SERVICE BULLETIN

Service Bulletin No.: DA20-27-02, Rev. 0

Title: Trim Display Modification.

FIGURE 1.

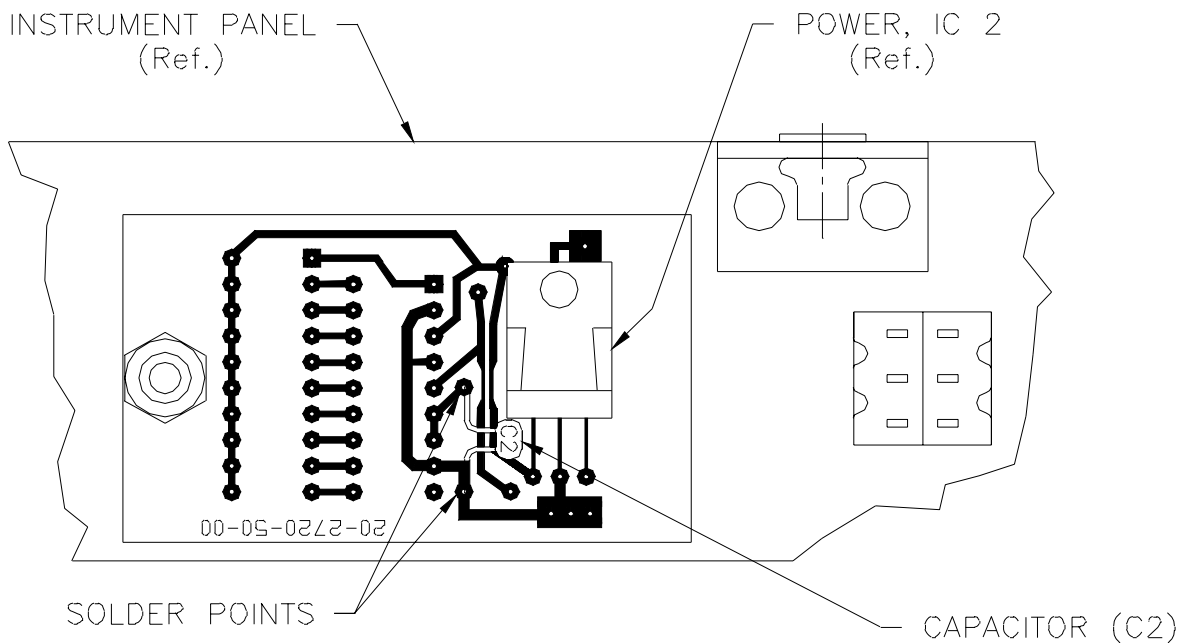
3. General: The existing Trim Indicator flickers when the VHF Transceivers are transmitting. This usually occurs in the higher end of the frequency range. The installation of this Service Bulletin will eliminate this occurrence.

11.1.3 Solder the Capacitor (C2) to the back of Trim Display as shown in Figure 1. It is important that the leads of the Capacitor are kept as short as possible. Make sure that the solder used is a resin core type.

7. Material:	Description:	Part Number:	Qty.
	Capacitor, C2	CW15C332K .0033uF+/-10%	1
